Re: ENERGYSTAR Central Air Conditioner and Heat Pump Version 6.1 Specification

Northwest Energy Efficiency Alliance (NEEA) staff submit the following comments in response to the United States (U.S.) Environmental Protection Agency (EPA) proposal to amend the recently completed Version 6.0 ENERGY STAR Central AC/Heat Pump (CAC/HP) specification, which will be reflected in a Version 6.1 specification.

#1 Maintain removal of EER requirement for cold climate category

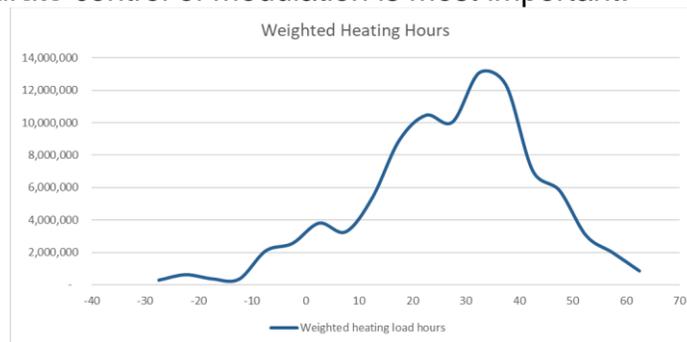
1. EER requirements for the cold climate category appropriately is appropriate and recognizes the cold climate category specification should focus on differentiating systems optimized for heating performance and efficiency.
